**From:** Emma Sheppard  
**Sent:** 24 October 2025 09:27  
**To:** Planning.Responses  
**Subject:** FW: LLFA comments  
**Attachments:** 0 - 251022 V3 Bognor BWB Response to ADC Objection FINAL COMPLETE.pdf; 0 - 251022 V3 Bognor BWB Response to LLFA Objection COMPLETE.pdf

Thank you for advising on the LLFA comments received on the RM.

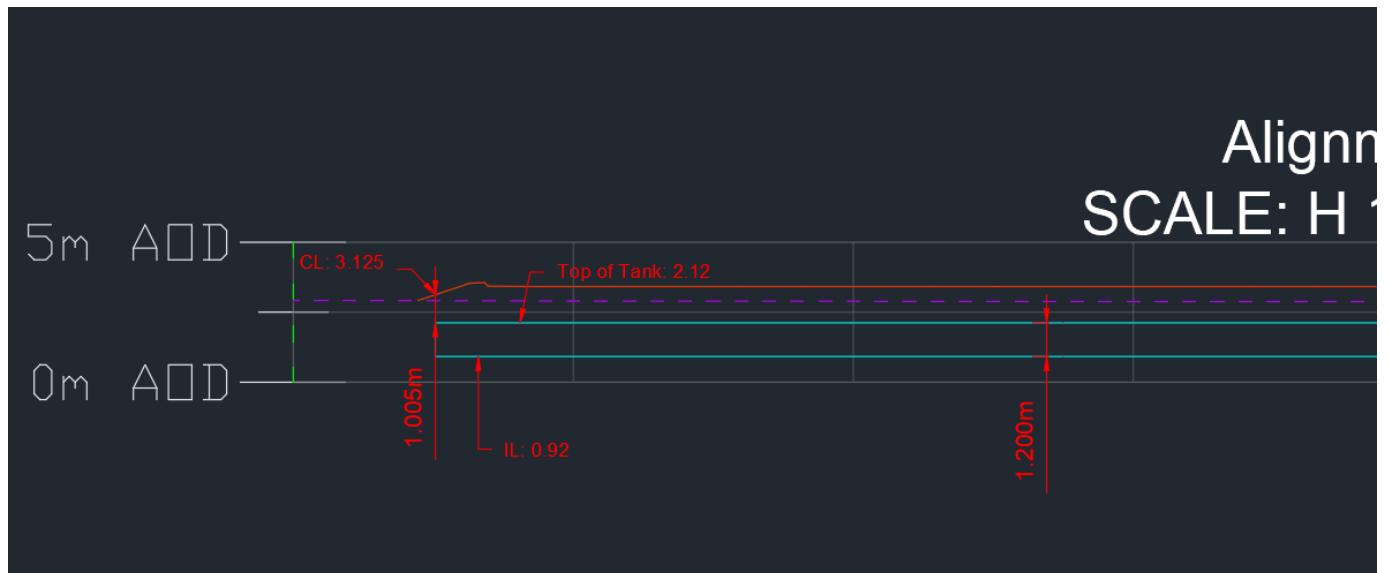
BWB have clarified that there is no conflict between the tanks and the ponds. The eastern tank has approximately 280mm clearance from top of tank 2.02m AOD and bottom of pond 2.30m AOD as shown below.

A clarification has been added to the drainage layout plans within the response notes, and I therefore attach updated responses notes for the LLFA and ADC Drainage Engineers. To confirm, there is no amendment to the drainage layout or drainage scheme as a result.
